CITY OF NORCO  
2870 Clark Avenue  
Norco, CA 92860

ADDENDUM NO. 1

**CRESTVIEW DRIVE STORM DRAIN IMPROVEMENT PROJECT**

ES-8B

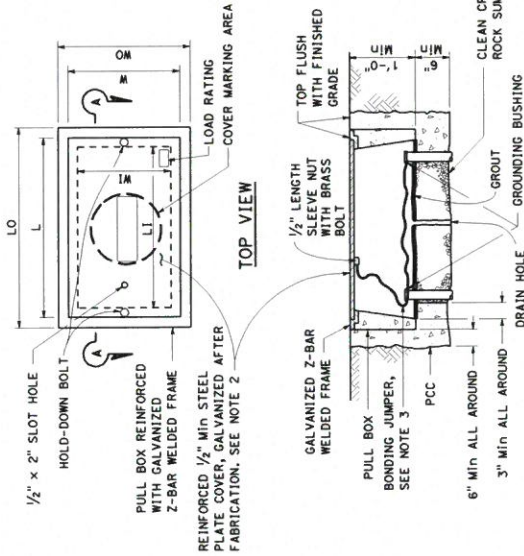
3. *Please provide a detail for the pull boxes.*

**Response:** Contractor to utilize Caltrans Std. ES-8B for replacement of pull box. (Standard Attached)
